Bedhead Call Button Release Note

(2026-01-12)

Device Model	DS-KHH6020X、DS-KHH6020X-H
Firmware Version	V2.3.11_build260112

Wiring diagram of alarm button

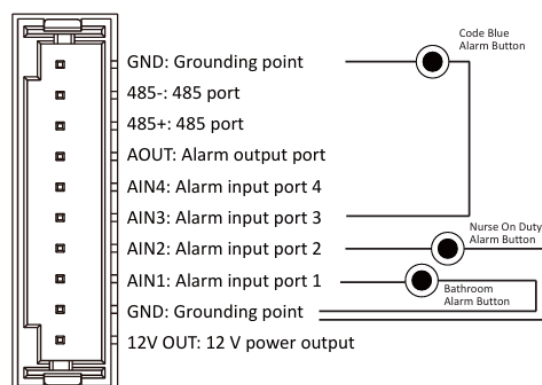
1. Add support for Nurse on duty button and Code Blue alarm button to Bedhead call button. The connection method is Alarm input, with a short press to trigger and a long press of 3s to cancel. The Code Blue trigger depends on the Nurse on duty button already being triggered;
2. The alarm button wiring instructions for the bedhead call button must follow the one-to-one correspondence in the diagram. This is hardcoded in the new firmware:
